SUBJECT: Forwards Westinghouse Justification for use of W-3
 correlation w/1.3 design limit DBNR at pressure below
 1,000 psia for steamline break analysis. Approach taken in
 840412 ltr no longer required.

Subject: Justification for W-3 Correlation Below 1000 PSIA
R. E. Ginna Nuclear Power Plant
Docket No. 50-244

Justification of 1.3 Design Limit DNBR for the W-3 Correlation at Pressures Below 1000 PSIA

Figure 14.2-11

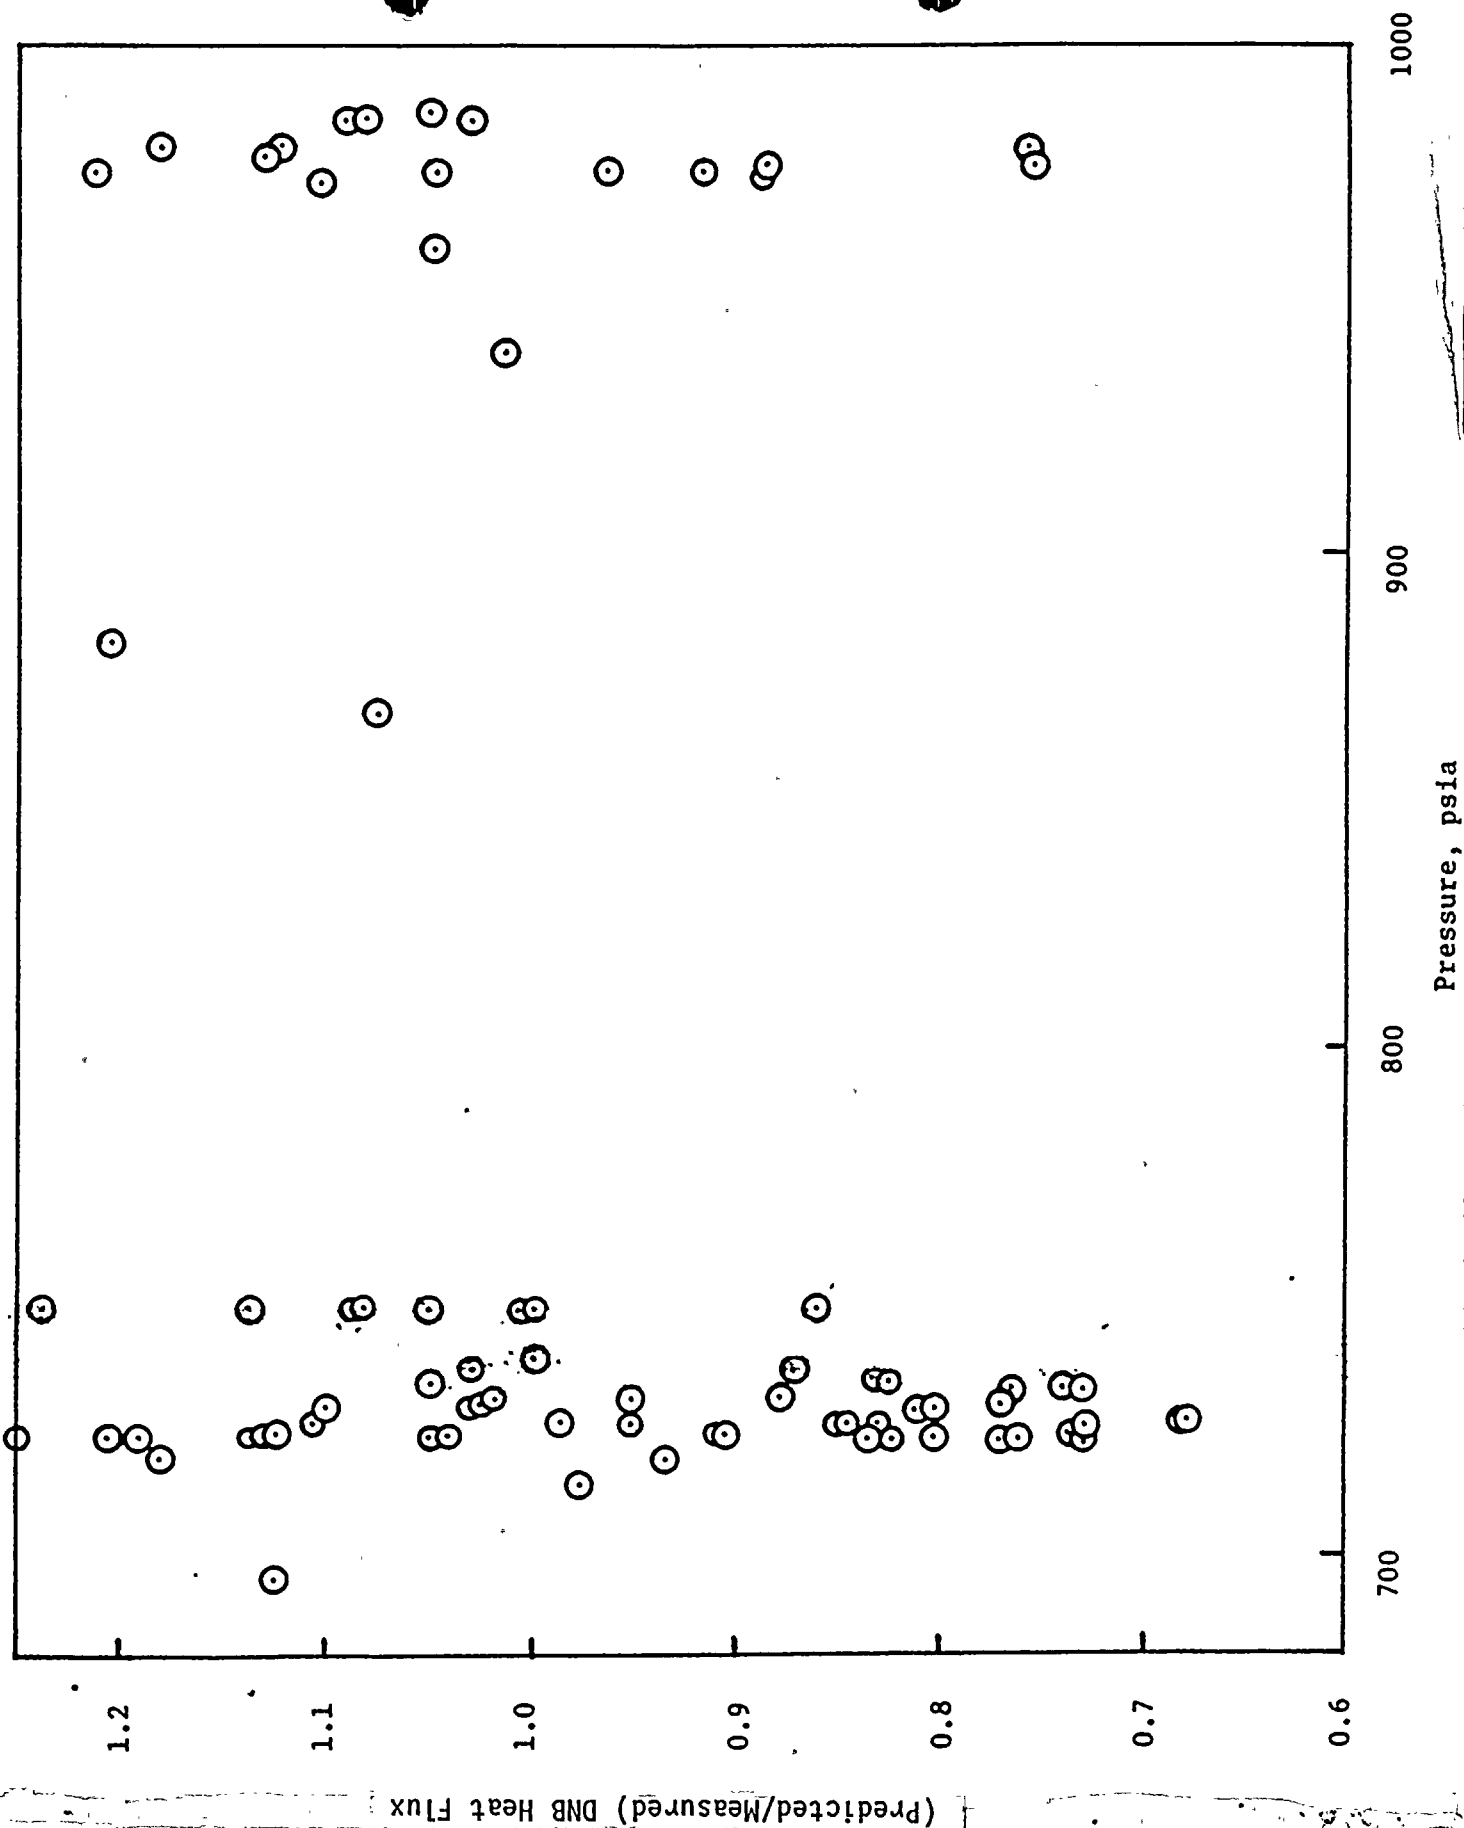
Reference 2 contains the results of an analysis of low pressure (700 - 1000 psia) data using the W-3 correlation. Those data were taken from the same sources as those used in the development of the W-3 correlation. As shown in the attached figure (taken from Reference 2) no anomalous behavior is observed for the low pressure data.
